STAFF REPORT
COMMUNITY DEVELOPMENT DEPARTMENT

HEARING DATE: 5/20/2021
 TO: Planning & Zoning Commission
 FROM: Joe Dodson, Associate Planner
 208-884-5533
 SUBJECT: H-2021-0021
 Prevail North Subdivision

Annexation & Zoning of 5.63 acres of land with an R-8 zoning district and a preliminary plat consisting of 18 single-family residential lots and 3 common lots on 5.25 acres of land.

B. Preliminary Plat (dated: 5/7/2021)

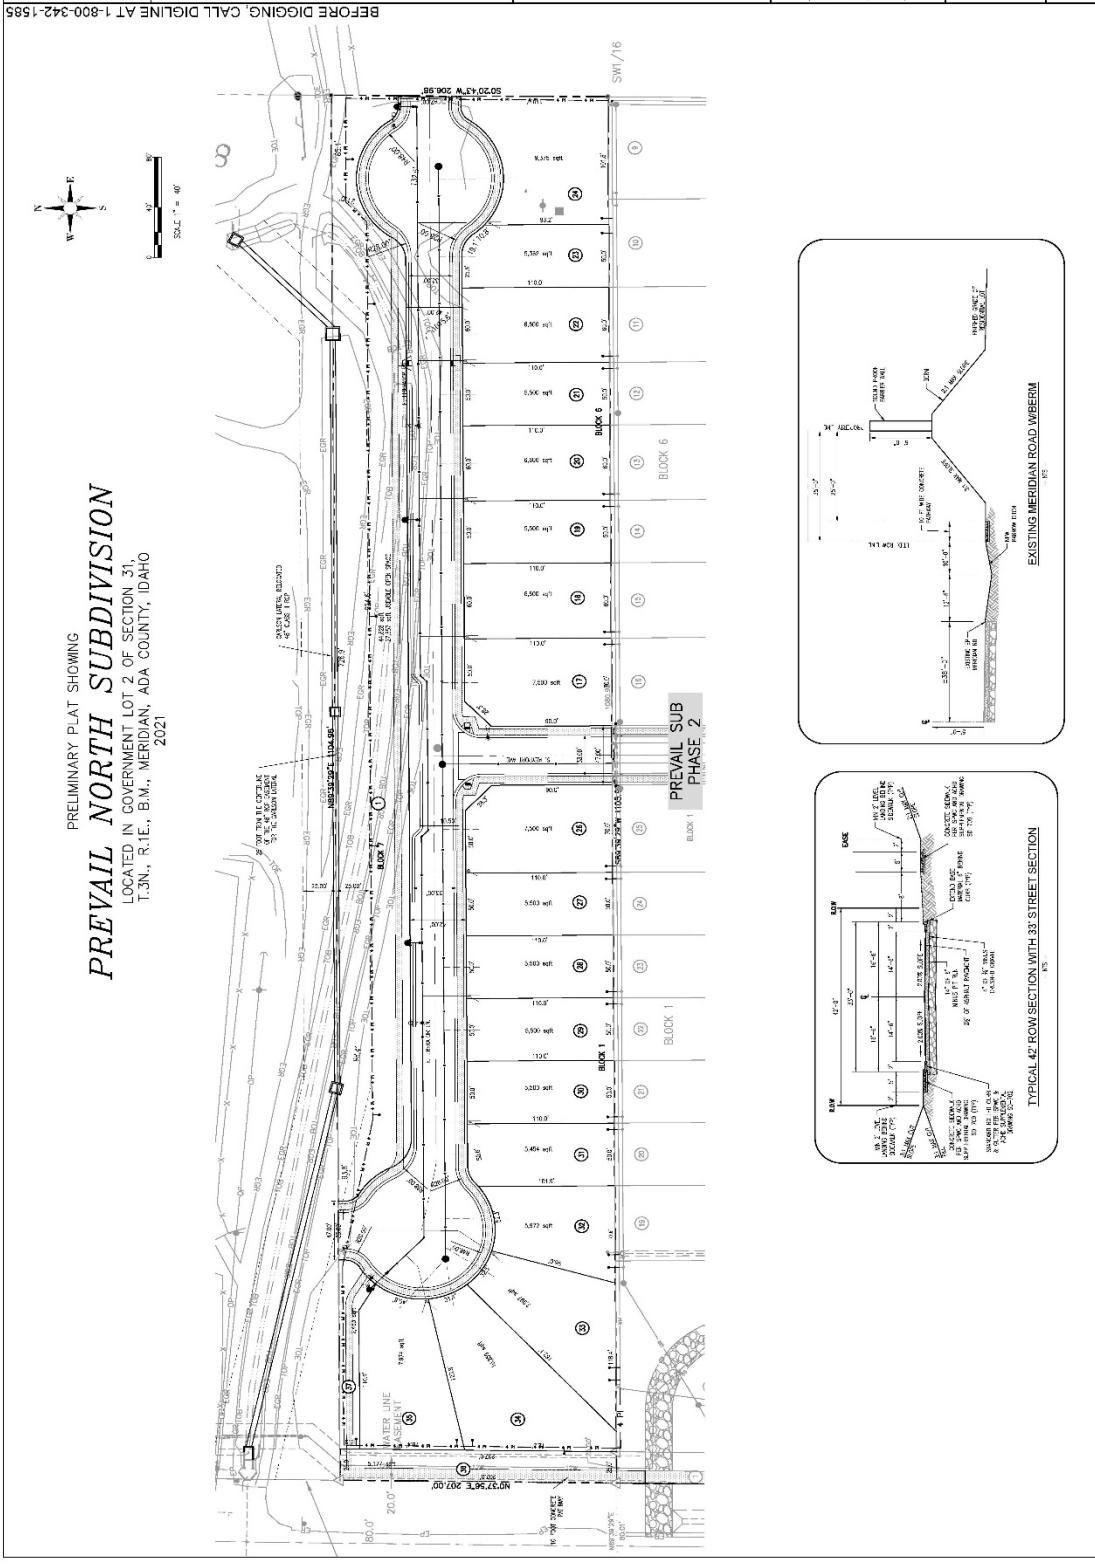
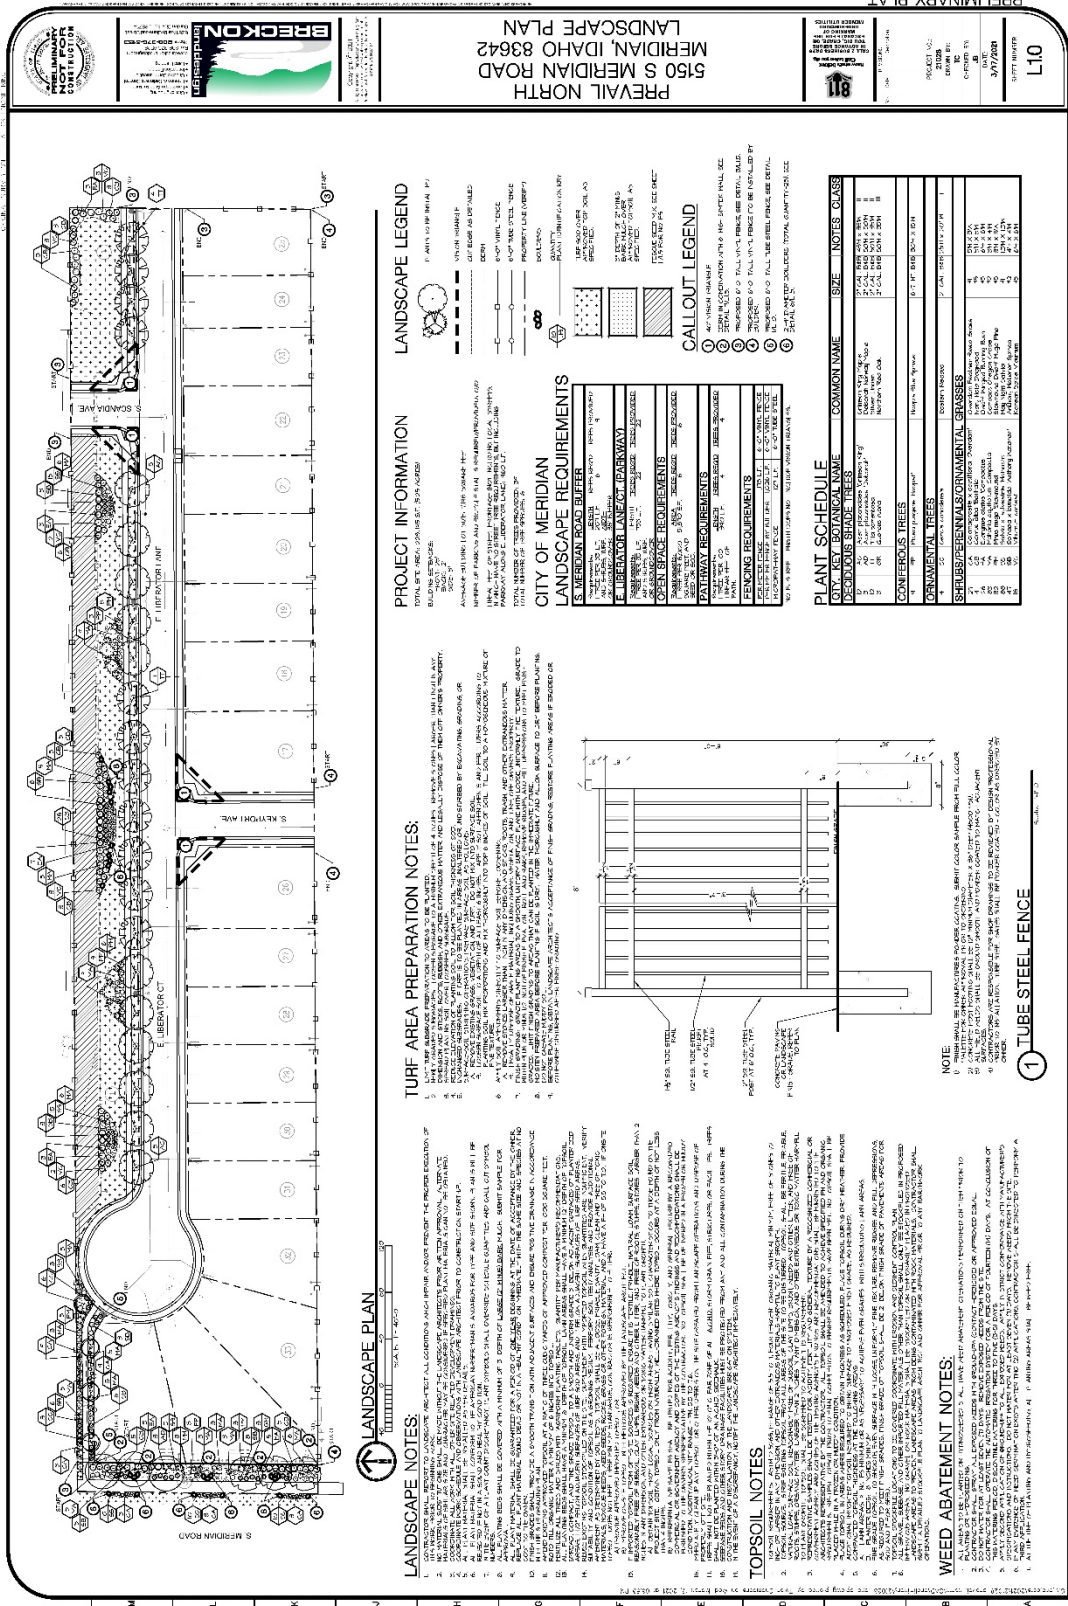
The proposed 8-foot wide parkway is approximately 740' in length on the revised plat requiring at least 21 trees (1 per every 35 linear feet). The submitted landscape plan does not show compliance with this requirement because it is shown with less than 21 trees. In addition, the plat

of the 5.25 plat area. However, this calculation uses the 25' landscape buffer width along Meridian Road instead of the required 35' width. Therefore, the actual amount of qualified open space should be slightly larger. The Applicant should correct the open space exhibit to reflect both the revised layout and the correct amount of qualified open space.

2. The preliminary plat included in Section VII.B, dated May 7, 2021, shall be revised as follows prior to submitting for Final Plat approval:
 - a. Revise the plat to show the landscape buffer common lot along Meridian Road to be at least 35 feet wide consistent with the required dimensional standards along an entryway corridor.

- b. Add a plat note stating that direct lot access to S. Meridian Road/SH 69 is prohibited.
 3. Revise the landscape plans, open space exhibit, and all other relevant plans to reflect the revised preliminary plat layout and provide revised plans to staff **at least fifteen (15) days prior to the City Council hearing.**

C. Landscape Plans (date: 3/17/2021) NOT APPROVED

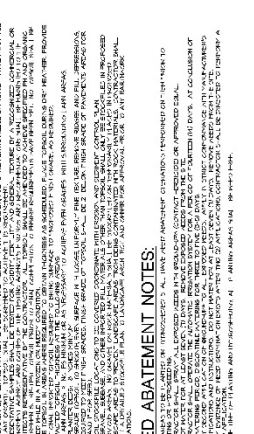
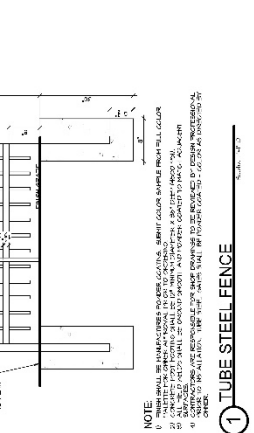
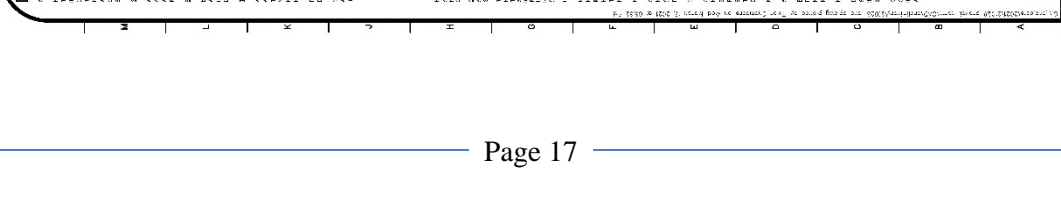
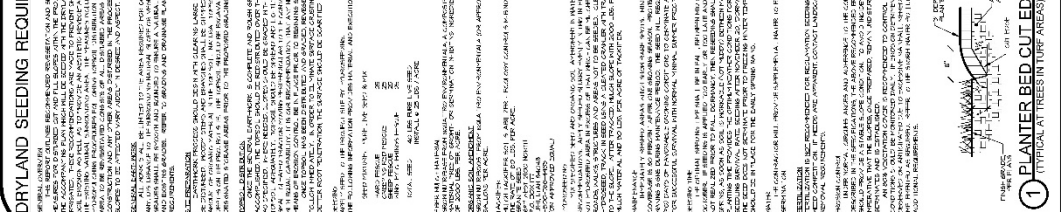
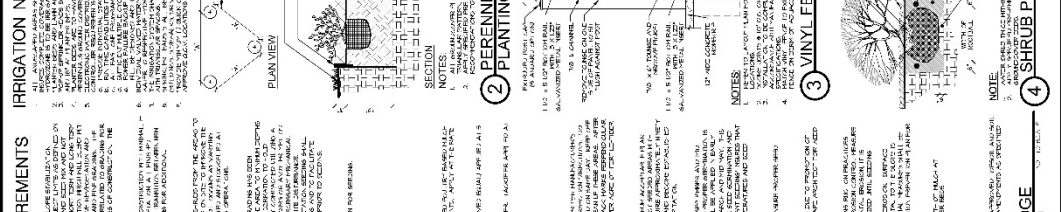
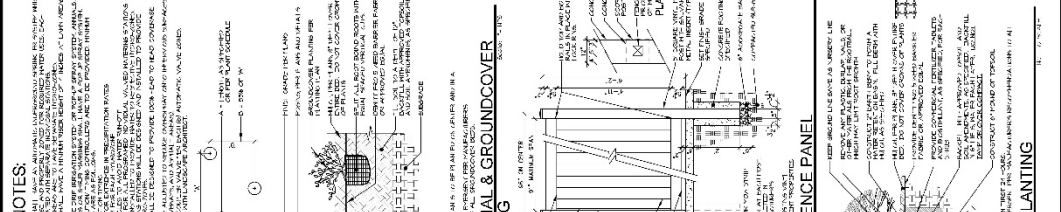
has been revised since the original application submittal and the submitted landscape plans have not been revised to match the new road layout. Regardless, the Applicant should revise the landscape plans prior to the City Council hearing to ensure they match the revised preliminary plat and show compliance with the landscaping requirements.

In addition, common open space is required to be landscaped with one (1) tree for every 8,000 square feet of open space. The large open space area is shown as 32,709 square feet in the development table on the preliminary plat. However, Staff's area analysis shows a figure closer to 36,500 square feet. Based on Staff's calculation, the minimum number of trees that are required within the open space lot is five (5) trees. The submitted landscape plans show six (6) trees proposed exceeding the minimum UDC requirements.

The landscape buffer along Meridian Road is required to be 35' wide and contain the required multi-use pathway within it. The submitted landscape plans show compliance with UDC requirements for the number of trees, tree spacing/grouping, and additional vegetative ground cover. However, the Applicant is only showing a 25' wide common lot on the preliminary plat for the required street buffer. Therefore, the Applicant should correct both the plat and the landscape plans to depict the required 35' wide buffer.

The Applicant is also proposing a micro-pathway from the western cul-de-sac to the multi-use pathway and does not appear to have the correct landscaping. UDC 11-3B-12 requires that trees be placed on both sides of the pathway; the Applicant has only proposed trees on the south side of the pathway. Staff is not aware of any easements encumbering the north side of the pathway and the landscape strip appears to be the minimum 5-foot width. Therefore, the Applicant should move one of the trees to the other side of the micro-path; Staff recommends the center tree of the three currently shown on the south side of this pathway.

Although there is no code requirement for this change, Staff also recommends removing the shrub bed located in the center of the large open space lot. By removing this planter bed and the shrubs there would be an unobstructed area in the center of the open space lot that is at least 9,000 square feet in size; it is rare for a subdivision to provide an area this large for children to play in without obstruction. If the Applicant desires to still include the same number of shrubs as currently shown, they could disperse them to the planter beds shown further to the west and east on the landscape plan.

4. The landscape plan included in Section VII.C, dated March 17, 2021, shall be revised as follows prior to submitting for Final Plat approval:
 - a. Revise the plan to show the required landscape buffer along Meridian Road to be 35' instead of 25'.

- b. Move one of the trees located on the south side of the micro-pathway in the northwest corner of the site to the north side of the pathway consistent with UDC 11-3B-12.

- c. Remove the center planter bed within the large open space lot, shown as Lot 1, Block 7.
 - d. Plant the proposed 8-foot wide parkway along the north side of Liberator Street with at least one (1) tree per 35 linear feet consistent with UDC 11-3B-7C.

- e. Any landscaping within the ITD right-of-way shall be landscaped in accord with UDC 11-3B-7C.5.
5. Future development shall be consistent with the minimum dimensional standards listed in UDC Table 11-2A-6 for the R-8 zoning district.

E. Open Space Exhibit – NOT APPROVED

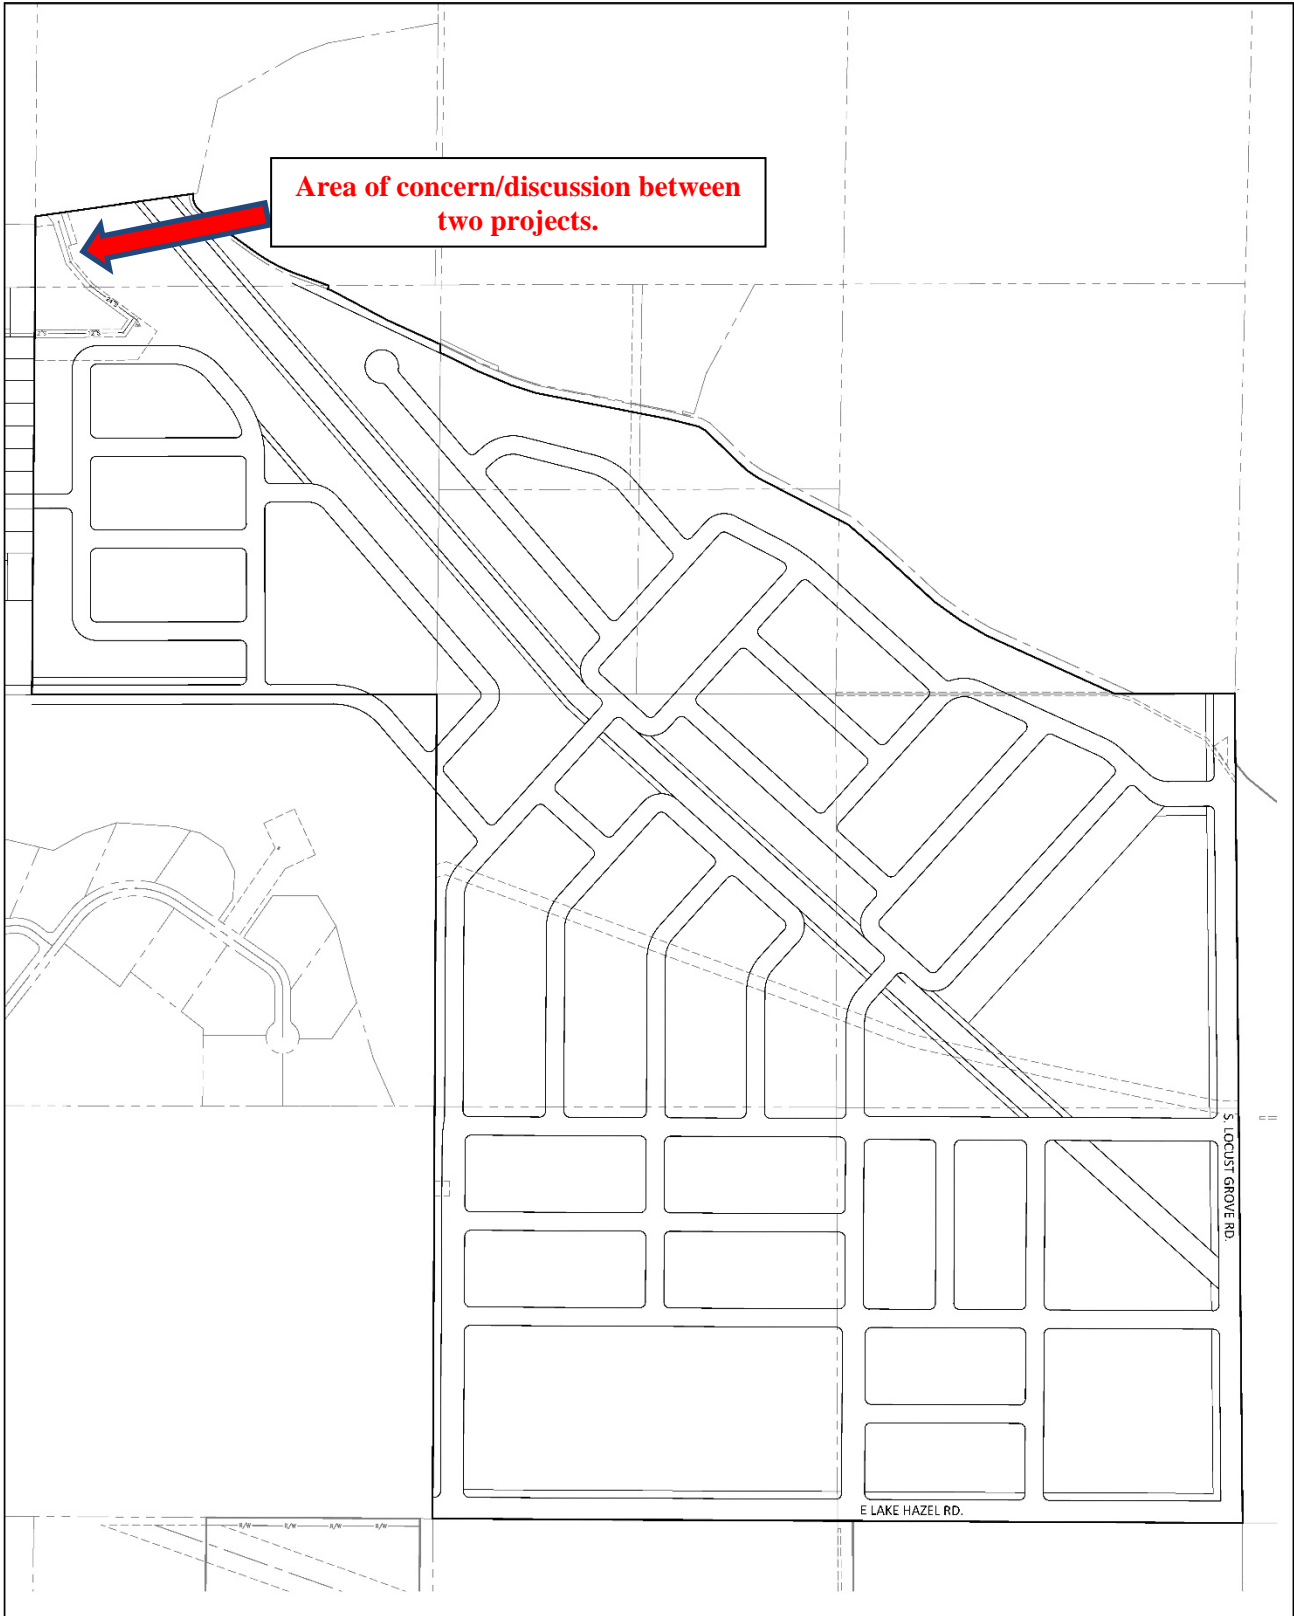
As discussed previously, the Applicant is proposing open space in excess of the code required 0.56 acres. Overall, the Applicant is proposing the large open space lot along the north property boundary, a micro-path lot, and the landscape buffer to Meridian Road as qualifying open space—cumulatively these areas amount to 49,878 square feet, or 1.15 acres, approximately 22%
